REMARKS/ARGUMENTS

In response to the Office Action, Applicant requests re-examination and reconsideration of this application for patent pursuant to 35 U.S.C. 132.

FIG. 1

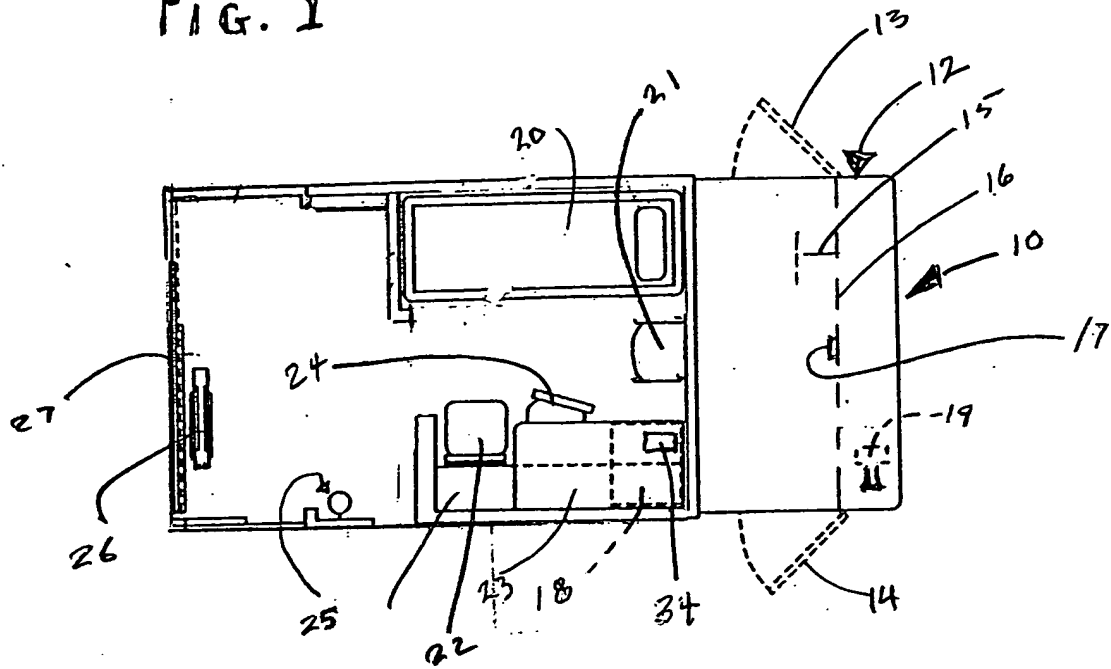
In amended Figures 1, 3 and 4, the previously omitted element numerals 34, 56, 57 and 66 have been added.

In the amended drawings a depiction of the printer 34 is added and another door latch 66 is added. No new matter is added.

FIG. 4

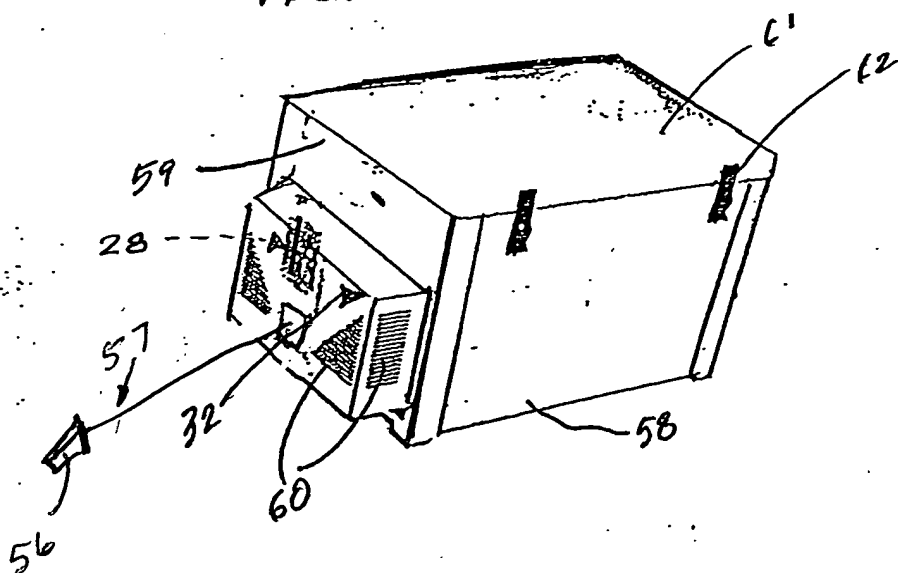
The heating unit is shown in the compartment, in Fig. 4, as is the vent 64 which connects the refrigeration unit to the interior. The devices are "mounted on" the compartment as shown and described in the specification.
